Subject: New Don Pedro Project, FERC No. 2299 FWS Filing of Final Report
Relating to Flow-Overbank Inundation Relationship on the Tuolumne
River

**FLOW-OVERBANK INUNDATION RELATIONSHIP FOR POTENTIAL FALL-RUN
CHINOOK SALMON AND STEELHEAD/RAINBOW TROUT JUVENILE
OUTMIGRATION HABITAT IN THE TUOLUMNE RIVER**

Response-to-Comments Document

Figure 3. Lower Trilumne overbank inundated area as a function of discharge

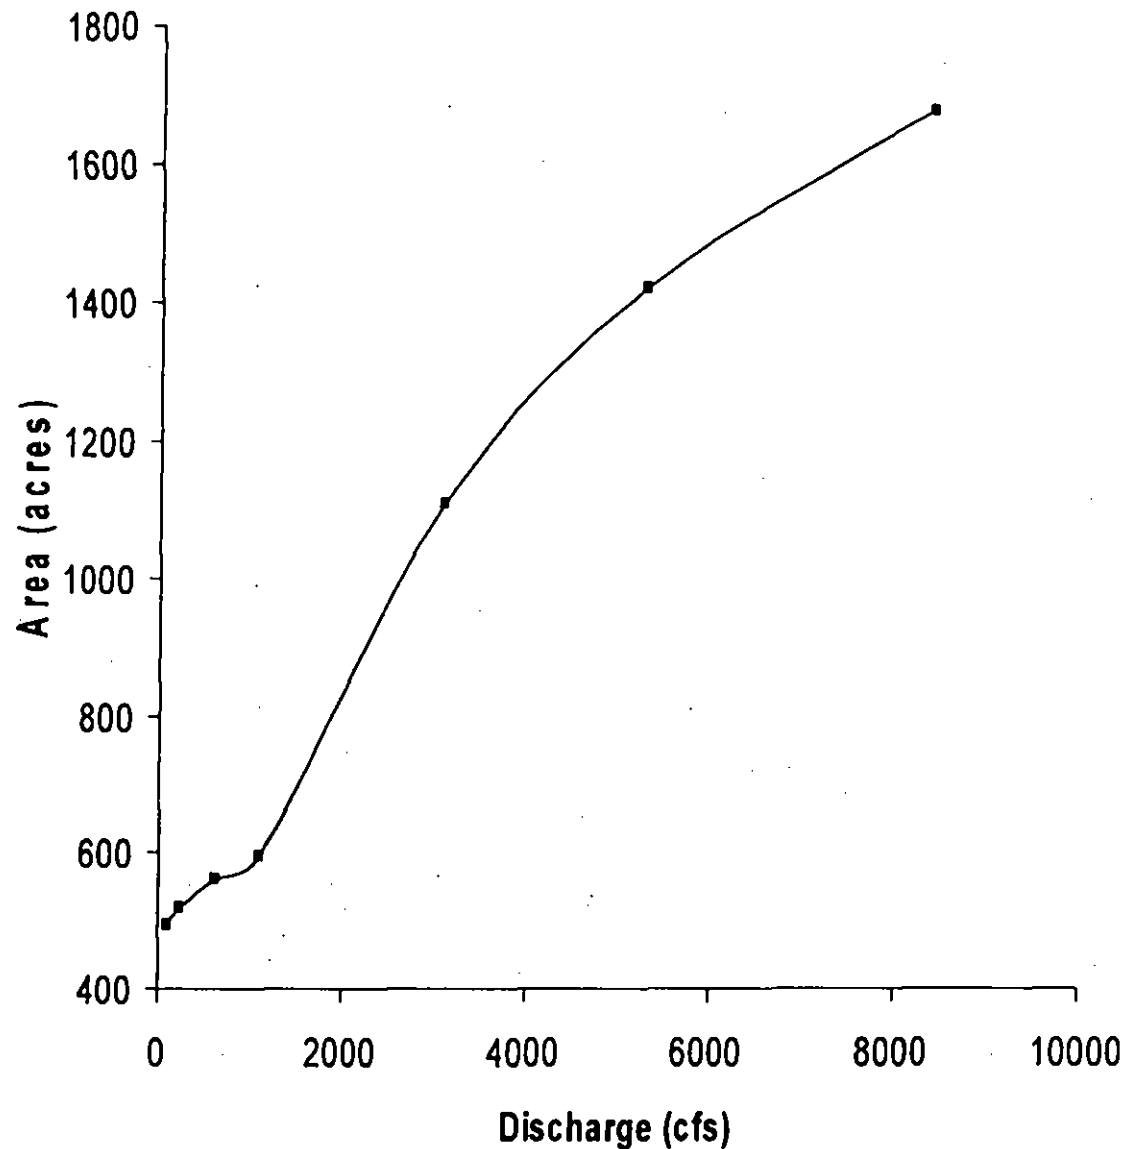
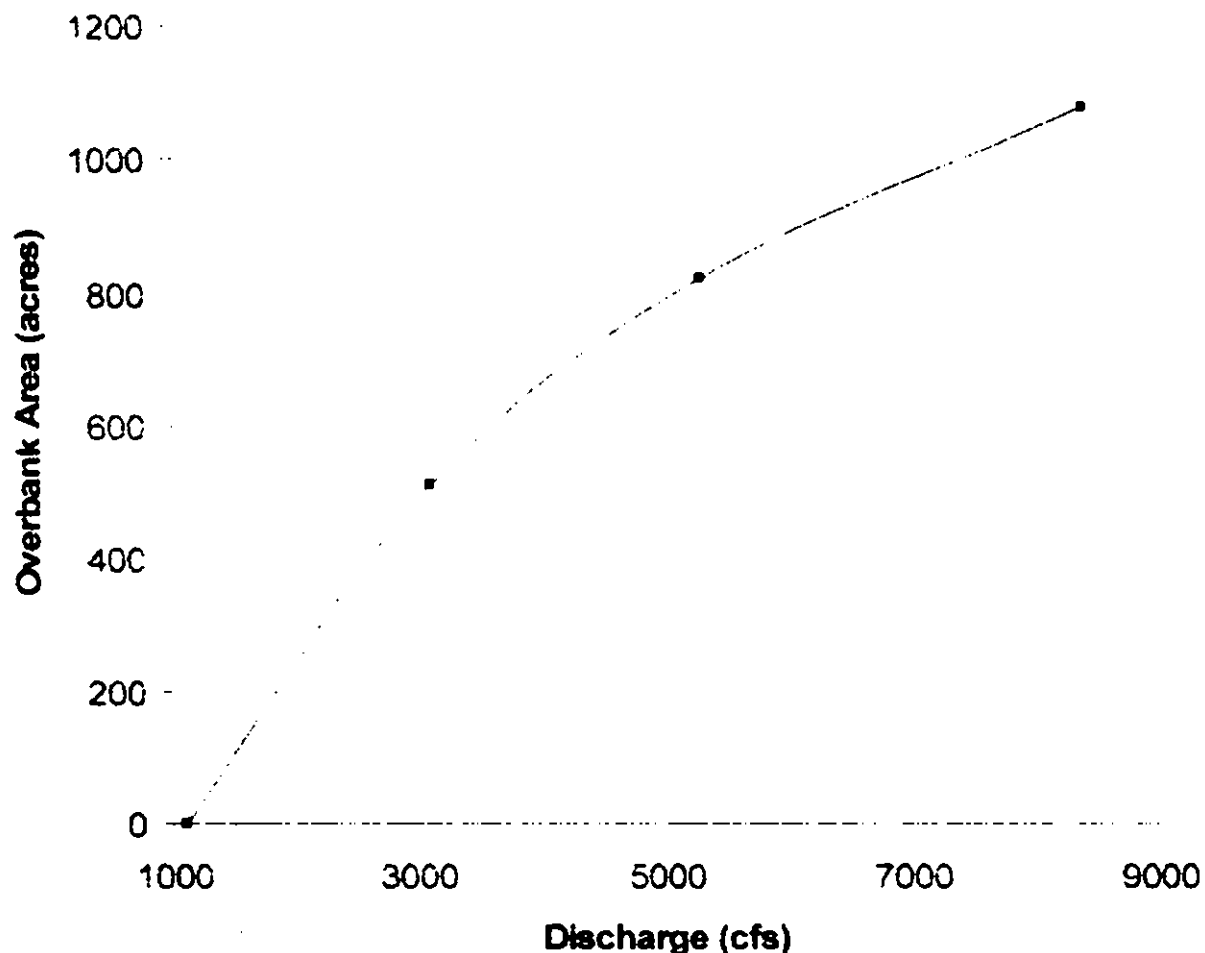
Comment 7: Table 2 and figure 3 are repetitive. Figures 2 and 3 are the same.

Response: With regard to the first part of the comment, we have provided the results in tabular form, in addition to the graphs, to increase the utility of the information in future resource planning efforts. Depending on the use, we feel that some readers may prefer the actual numbers, rather than only a graphical representation. We will therefore keep Table 2.

Concerning the second part of the comment, we have now included greater detail explaining that Figure 3 represents only acreage for inundated overbank or potential floodplain, the channel acreage having been subtracted from the total inundated area at each flow above 1,100 cfs.

Comment 1: Page 6 – "The resulting Area vs. Discharge curve is displayed in Figure 2, with the same data also presented in Table 2. This area also includes the area of the channel the channel." You do not need to show the data and table and figure form. Pick one. I would go with the graph. Take out the second "the channel" in the second sentence.

Response: We have provided the results in tabular form, in addition to the graphs, to increase the utility of the information in future resource planning efforts. Depending on the use, we feel that some readers may prefer the actual numbers, rather than only a graphical representation. We will therefore keep Table 2. The correction in the second sentence was made.

Figure 4. 620 cfs wetted perimeter between RM 30 and 31. No ponds visible.

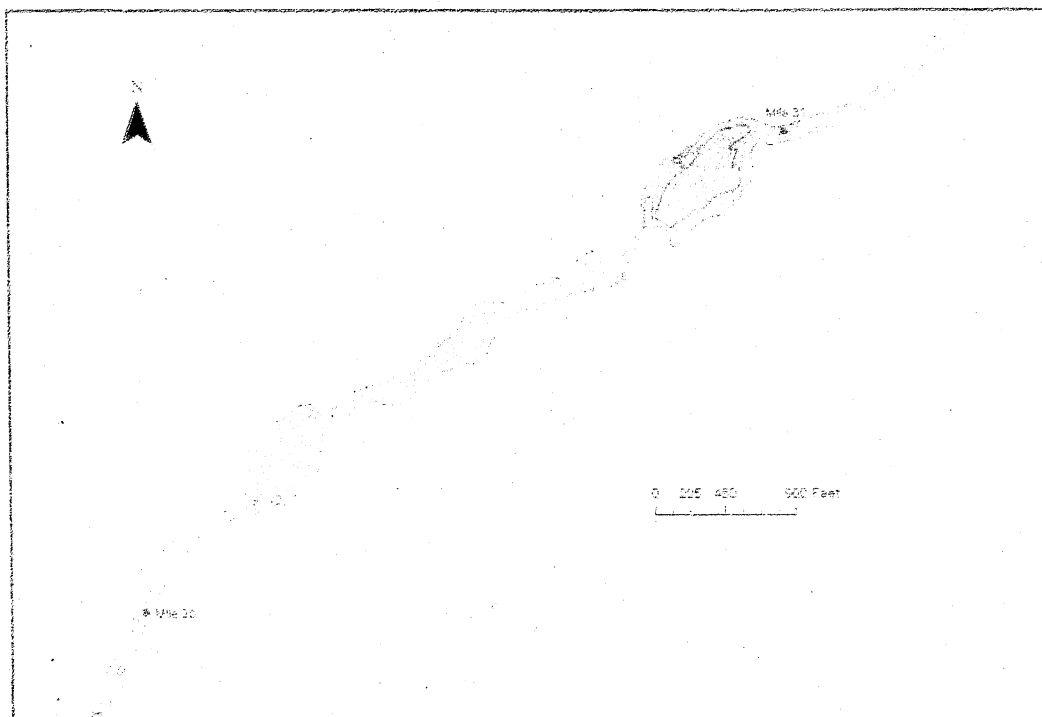
Comment 5: Page. 9 - Figure 4 title - font change, punctuation missing.

Response: Thank you, the corrections have been made.

Figure 8. 4,030 – 4,070 cfs ponds visible and connected to channel RM 30.5.

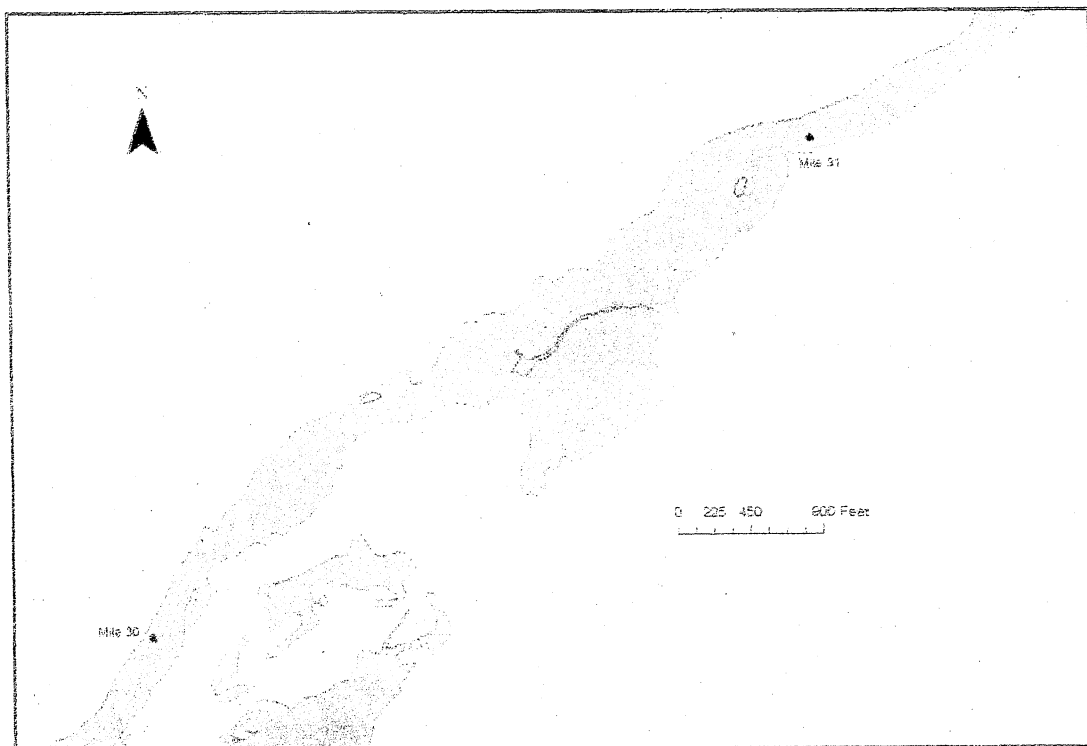
The role of NAIP data (air photos) in the analysis is unclear. Were these photos also georeferenced and used for the study? If not, I am not sure why Figure 8 is included.

Comment 7: The text on p. 7 refers to NAIP imagery at flows of 4,030 cfs and 2,680 cfs, but only the low flow example is included. It is hard to draw conclusions about water in the pits at different flows based on this single figure. Other figures and graphs are clear and well-labeled.

Comment 7: I don't understand the significance of this single photo (Figure 8), and no other NAIP photos are offered for comparison. Is this photo necessary?

USGS georeferenced topo layers were used with the NAIP imagery for the truthing of features and indentifying locations on the polygon layers. The figure was included primarily as an example of how the pits actually appear, on the outside chance that anyone in the audience this report is intended for was not already familiar with the area. It has been replaced with a NAIP image of the same River Mile (RM) 30.5 area shown in Figures 6 and 7 for comparison.

Response: It was decided for Figure 8 to use instead NAIP imagery for the same RM 30.5 area shown in Figures 6 and 7 for comparison. The text has been rewritten for clarification with an addition being made that Figure 8 was originally included primarily as an example of how the pits actually appear, on the outside chance that anyone in the audience this report is intended for was not already familiar with the area.

Response: The photo was originally included to give any readers not familiar with the lower Tuolumne River some idea of the appearance of the gravel pit and dredge mining areas. The figure has been replaced with a NAIP image of the same RM 30.5 area shown in Figures 6 and 7 for comparison.

Figure 9. Mean daily flows for the Tuolumne River below Lagrange, 1970-2007.

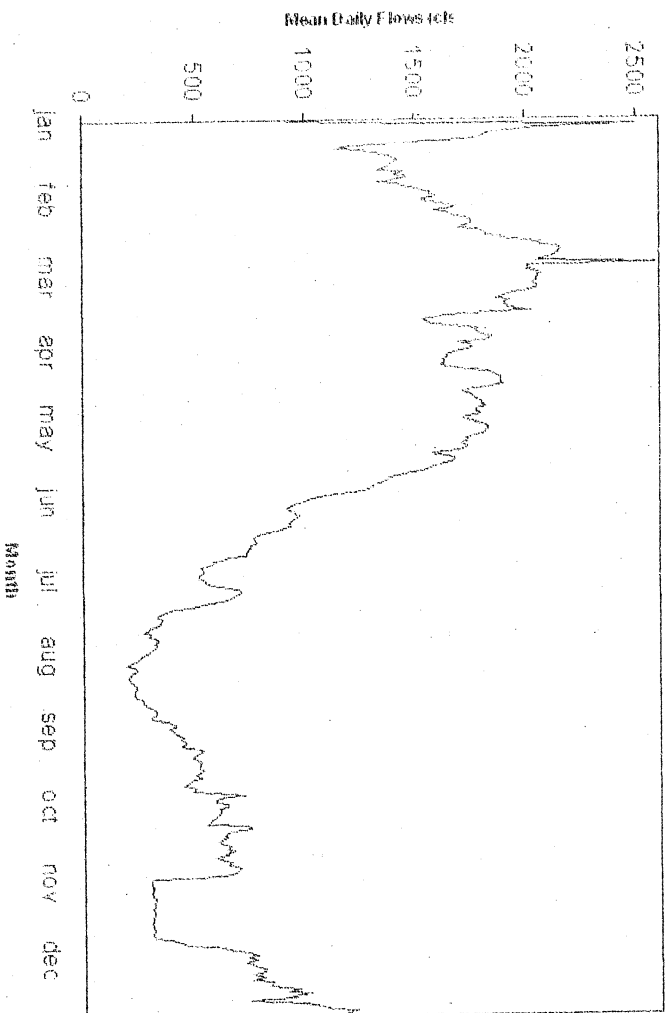
Comment 2: I would like to see more discussion about the significance of this range of flows. What is a normal summer flow, and what is an average winter flow? Is 8,400 cfs a big number (i.e., what is the recurrence interval)?

Response: A hydrograph of mean daily flows from 1970-2007 using USGS "Below LaGrange" gage data has been added. A 2004 California Department of Water Resources report shows an exceedence frequency at 8,400 cfs of around 15% for at least a single occurrence at this site in any one year.
